# CITY OF ALBUQUERQUE

**RE: 1428 Stagecoach Rd SE**  
**Grading and Drainage Plan**  
**Stamp Date: 1/16/17**  
**Hydrology File: M23D019**

Based upon the information provided in your submittal received 4/7/2017, the Grading and Drainage Plan **is not** approved for Building Permit. The following comments need to be addressed for approval of the above referenced project:

## GRADING AND DRAINAGE PLAN

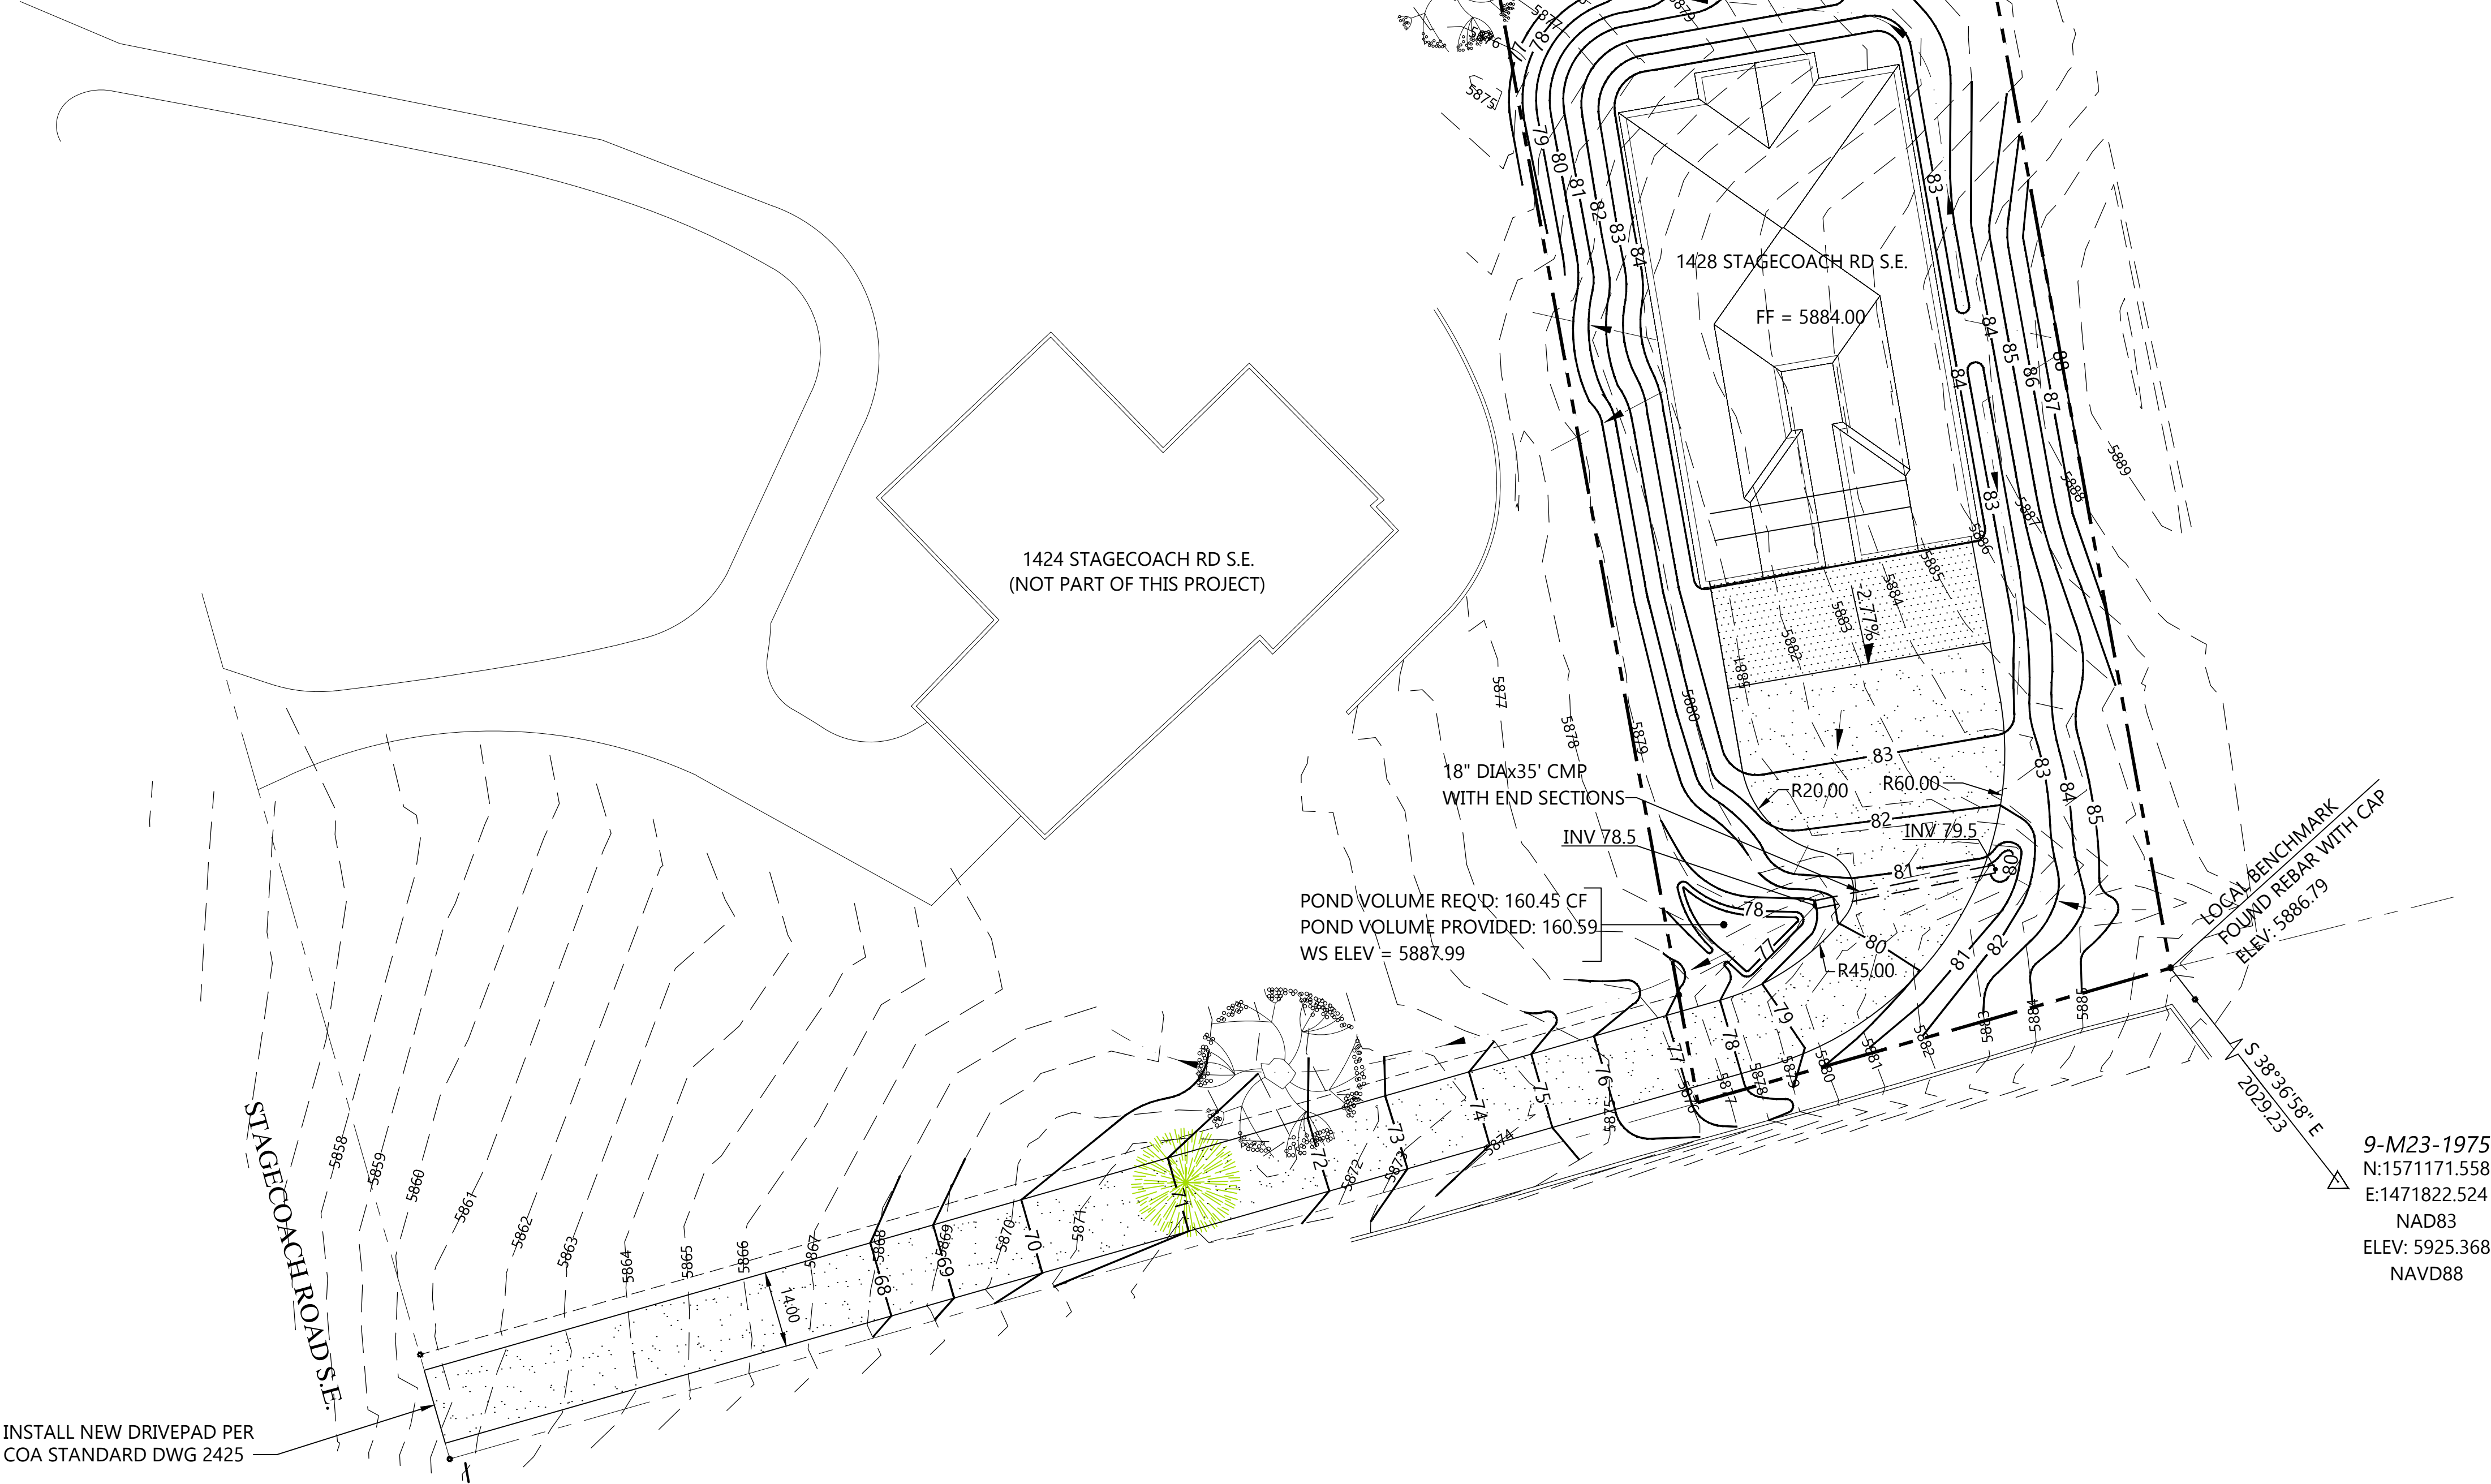
1. This site appears to be replatted. The lot size from the Appraisal District is listed as 0.4849 ac and the lot size that is quoted in the calculations is 0.60 ac. Please clarify which is correct.

2. Please label the access easement. Is it a 20 ft easement?
3. On the drainage calculations, this site is in Precipitation Zone 3. Therefore all the drainage calculations needs to reflect Zone 3 and not Zone 1.

6. Please provide a drainage swale along the west property line towards the pond. The proposed finish floor is higher than the adjacent property. I would like to lessen the impact of the increase runoff onto the adjacent property.

7. Please continue the swale along the driveway past the existing tree to the road. Again, I do not want this property's runoff to cause issues with the adjacent property.

## DRAIN PIPE CROSS SECTION

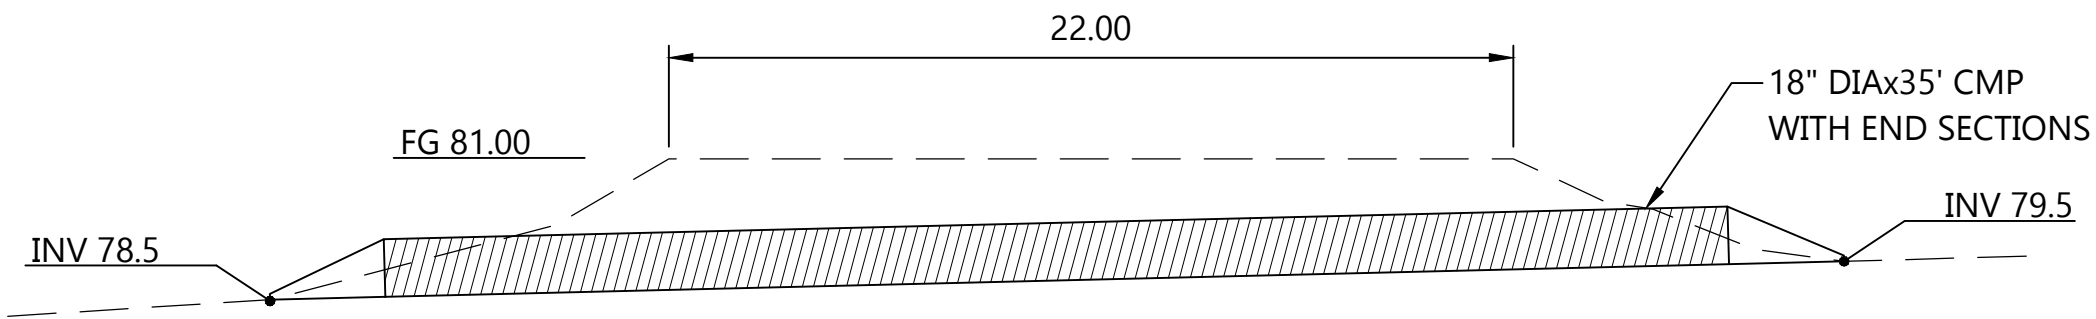
4. In the drain pipe cross section, please add 1 ft cover (min.) between the drive and the 18" CMP.
5. The water surface elevation for the pond does not match the pond volume calculations. Please correct.
